## Department of Planning and Zoning

**TO:** Design Advisory Board  
**FROM:** Scott Gustin  
**DATE:** July 23, 2013  
**RE:** 14-0038CA, 395 Manhattan Drive

**Request:** Demolish existing residential structure and construct new duplex.

WEST FACE  
(EAST FACE IS MIRROR)

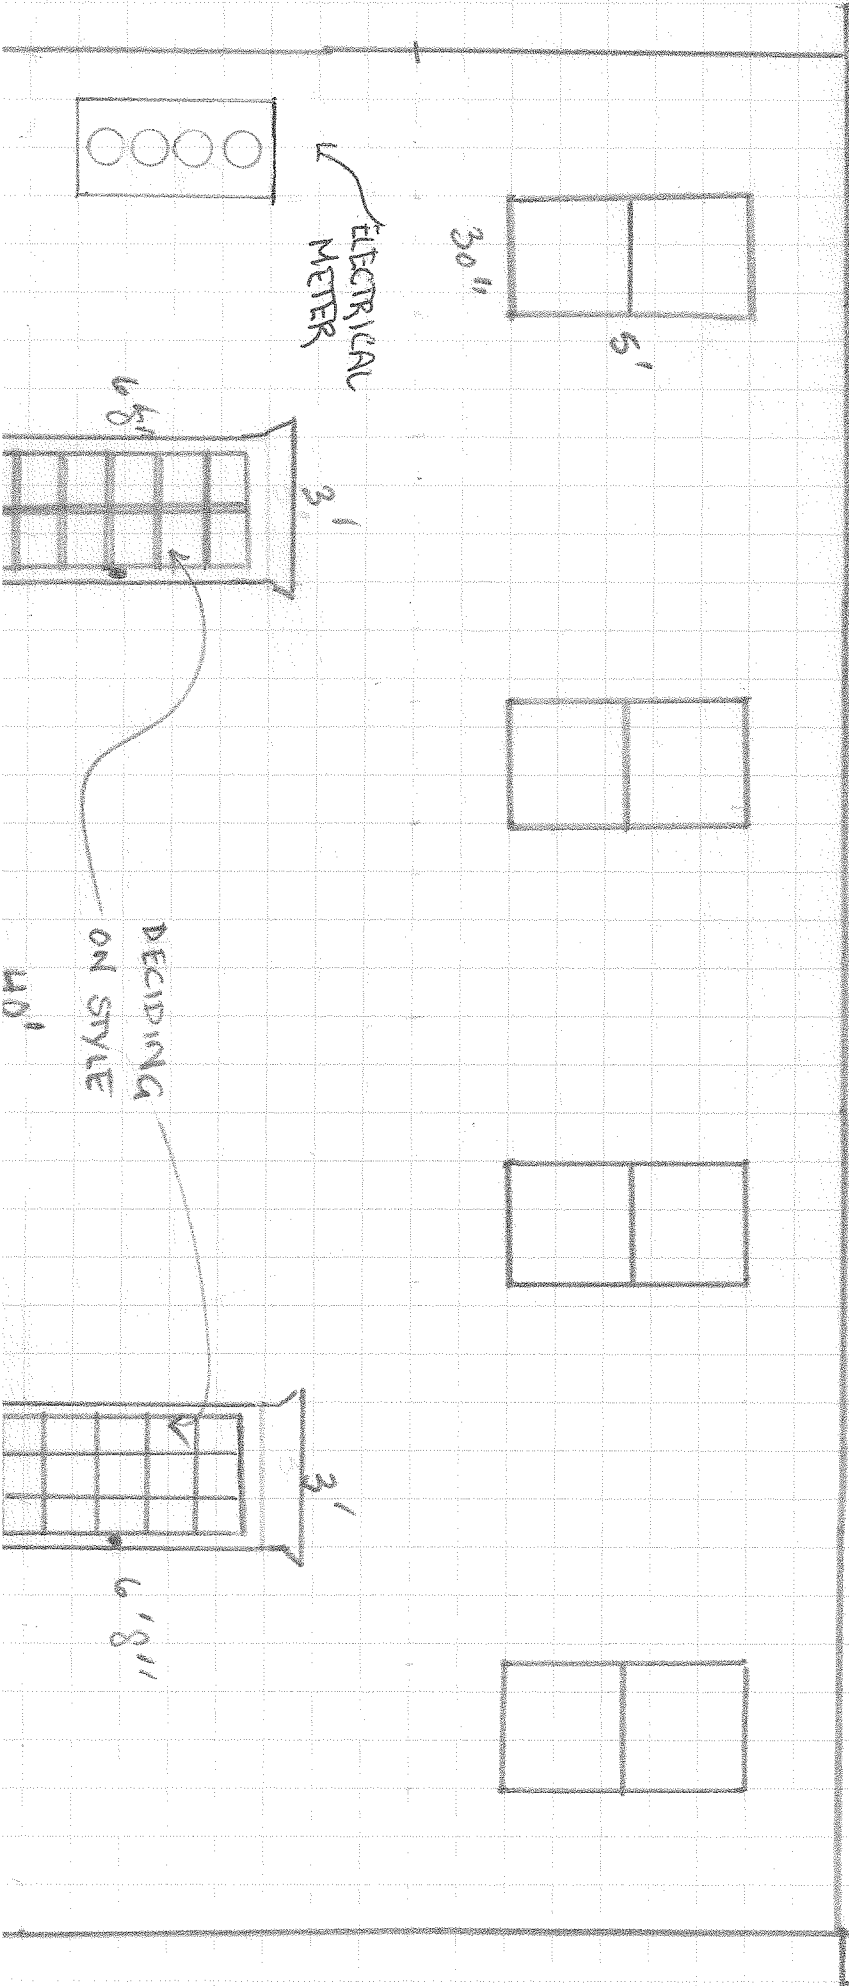
The front façade includes two garage entries. These entries are flush with the front face of the building and must be revised so that they are set behind the pedestrian entrance into the building. No specific setback distance for the garage doors is required; however, there must be a break in the building plane with the pedestrian entrance more prominent than the garage entries. A slightly projecting front entry may be the most appropriate option in light of the overall building design. The garage doors comprise some 53% of the total front façade width. This width is permissible so long as they are under a single roofline and wholly integrated into the overall building design and there is living space above them. Such is the case here.

Fenestration details provided are very limited. The window specification sheet depicts 1-over-1 double hung units whereas the elevation drawings suggest large 2-over-2 casement or awning units. Perhaps they are side-by-side double hung units. Clarification is needed. Trim and casing details are also lacking. Building entries are similarly lacking in detail. A front door is proposed, and what seem to be rear sliding doors are also proposed. Improved elevation drawings that depict all trim details are needed.

1. The front entry should be revised to project in front of the adjacent garage doors.
2. A landscaping plan should be provided that depicts generally what new plantings are proposed where. A rain garden is encouraged for receiving and infiltrating roof runoff.
3. Outdoor lighting fixture locations and cut sheets should be provided.
4. Windows depicted on the building elevations should match the windows in the cut sheets provided. Elevation drawings should show details accurately.
5. Trim materials should be noted on the elevation drawings.
6. The front façade should incorporate some variation in cladding to differentiate the upper floor from the bottom two floors (i.e. shingles vs. clapboards).
